Differences Between Models CTC062 and 770067

DRAWING NUMBER
 770067
 CTC062

DATE
 April
 2023

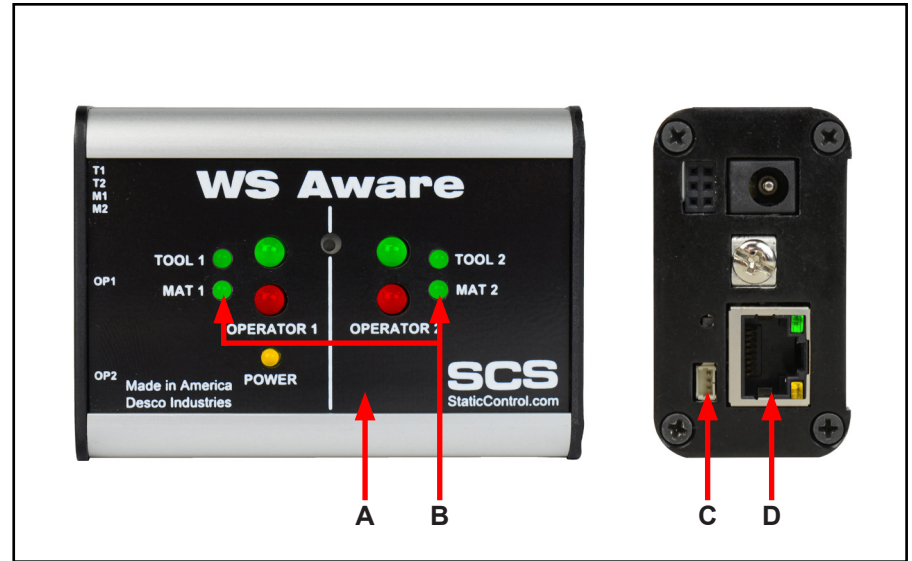
- A. Black face plate with new labeling for Tool, Mat, and Operator circuits.
- B. Tool circuits 3 and 4 replaced with Mat circuits 1 and 2.
- C. New terminal for use with the SCS [770069](#) Power Relay accessory.
- D. Connector with 4.20 mA output and optical relay terminal replaced with Ethernet jack that provides network communication between the WS Aware Monitor and [Static Management Program \(SMP\)](#).
